INFORMATION			
contract no.	scale	1 : 50 @ A3	
client ref.	Argent	date	FEB '13
drawn by	GP	checked by	
drawing no.	4142	SERV	SKE02
			11

project	Stanley South Building - Building E1
title	STANLEY BUILDING ROOM 2 TYPICAL LAYOUT

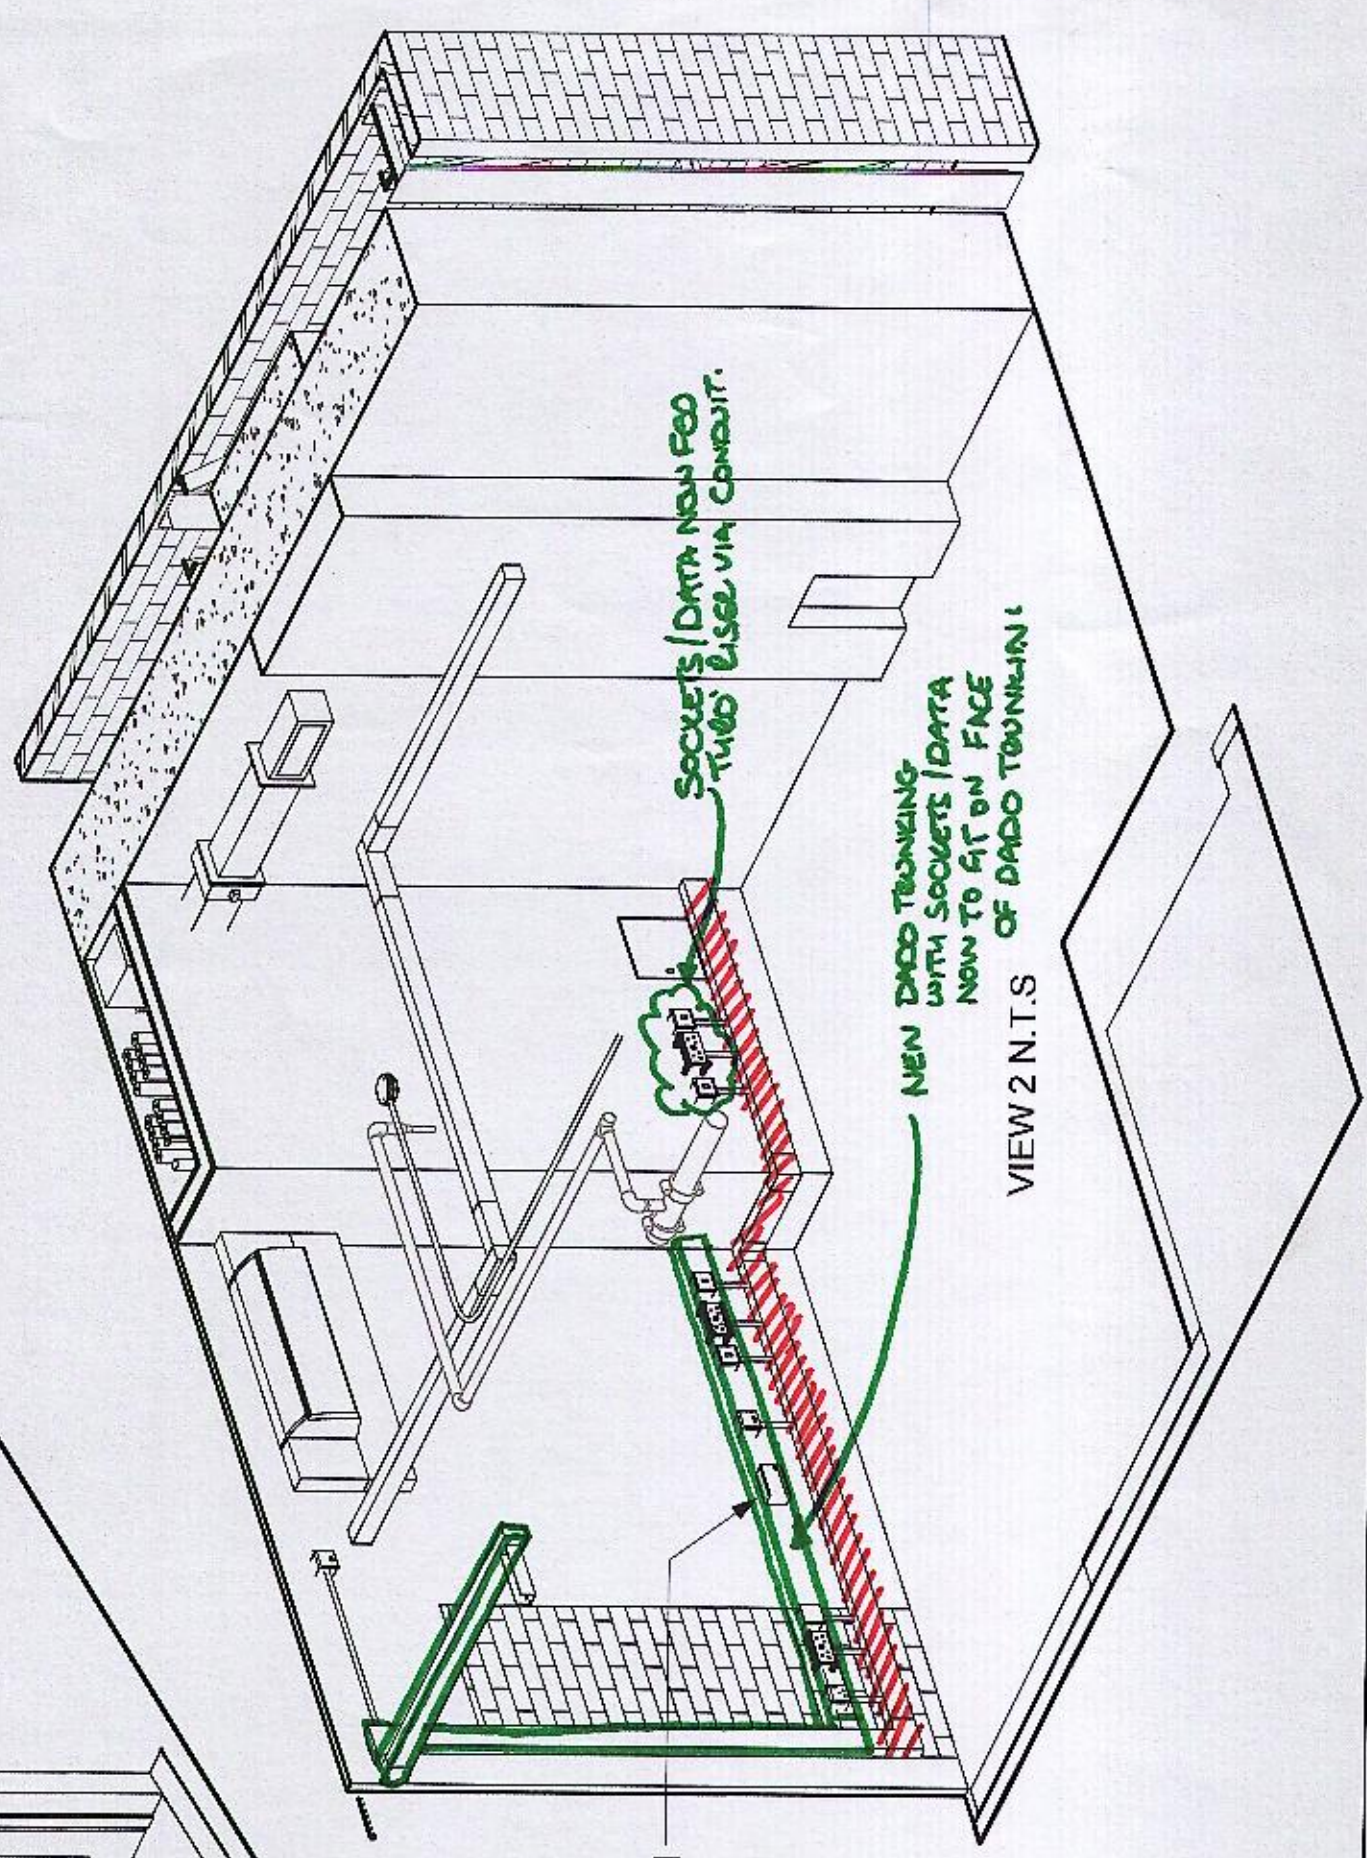
DE-ABANDONMENT OF SMALL POWER DATA
TRAINING TO TAKE ACCOUNT OF CONSERVATION
OFFICER COMMENTS.

PROPOSED REDUCED TRAINING
EXISTING TRAINING NOW REMOVED.

ORIGINAL TRAINING
OMITTED.

SOCKETS, NEW FEO VIA CONDUITS,
BURN IN FLOOR VOID.

TRAINING OMITTED.

REFRIGERANT LEAK DETECTION
ROOM 2 PLAN
SCALE 1:50

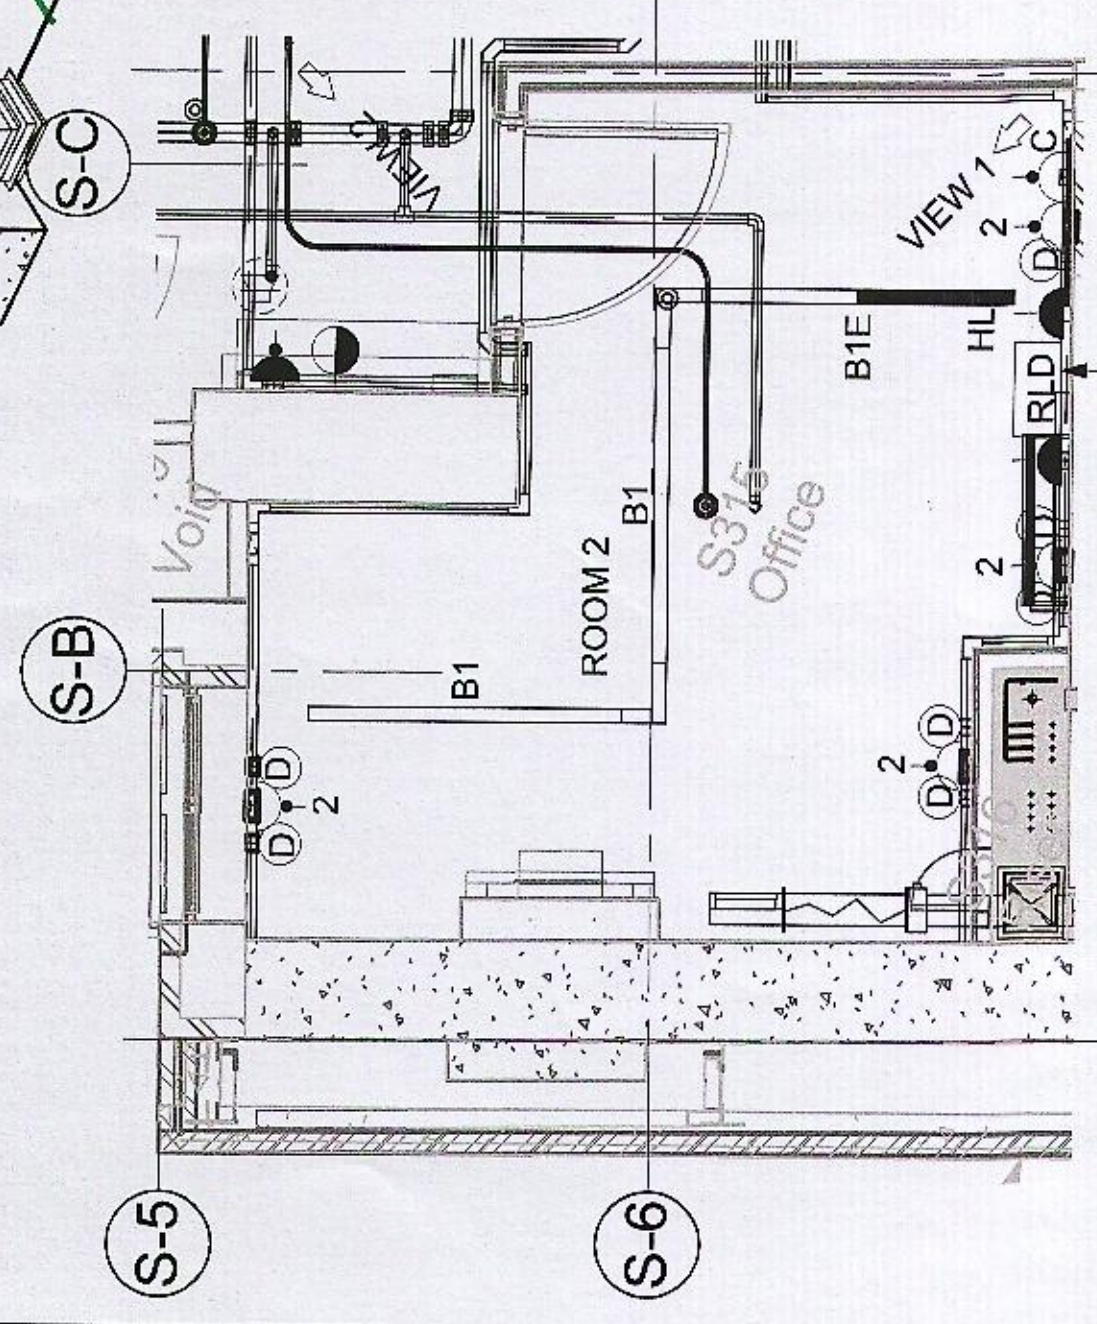
REFRIGERANT LEAK DETECTION
